IEEE 802.1 Minutes, March 2000

Albuquerque, NM

Tony Jeffree – 802.1w comments generating discussion (see disposition for others)

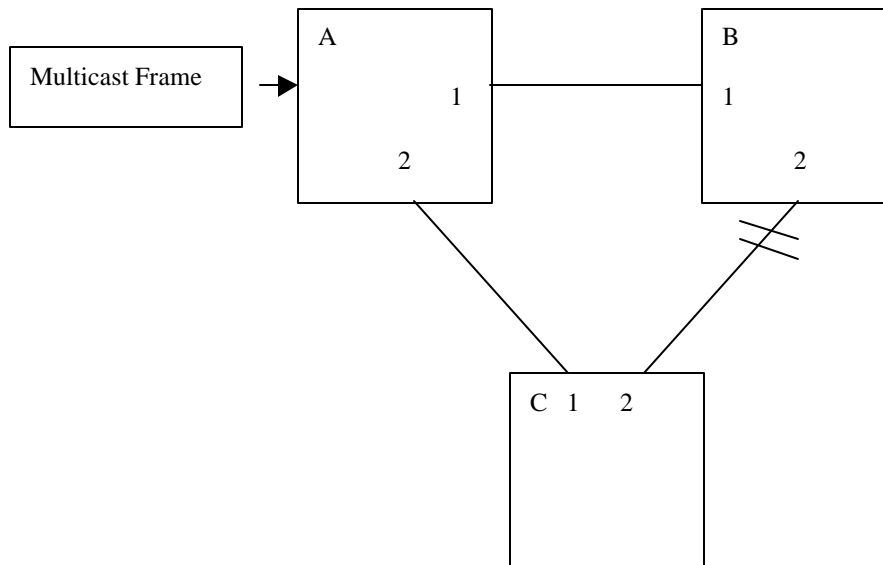
1. 802.1w must carefully address frame miss-ordering and duplication. Tony has distributed a separate document on the topic. The potential exists within 802.1w to put a port in forwarding much quicker and as a consequence the possibility of miss-ordering and duplication (in certain circumstances) is increased. There is a slight chance of single frame duplication during reconfiguration for unknown destination and multicast frames. Consider the following topology.

A multicast frame is received by bridge A and is forwarded to bridge B and C via ports 1 and 2. However, the delivery of the frame to bridge C is delayed because of congestion on A's output port 2. Meanwhile, the port between A and B goes down and B unblocks the link to C. The original multicast frame from A to C is finally delivered and is now delivered to bridge B twice; once by bridge A before the link went down and again by C after the reconfiguration.

A ring topology such as the one above is the worst case scenario. The problems can be reduced if you require that the input ports be flushed upon a link that has gone down and run short aging timers for a period after reconfiguration.

The resolution to the ballot comments related to miss-ordering and duplication is to acknowledge this can occur in the text at 6.3.3 and 6.3.4.
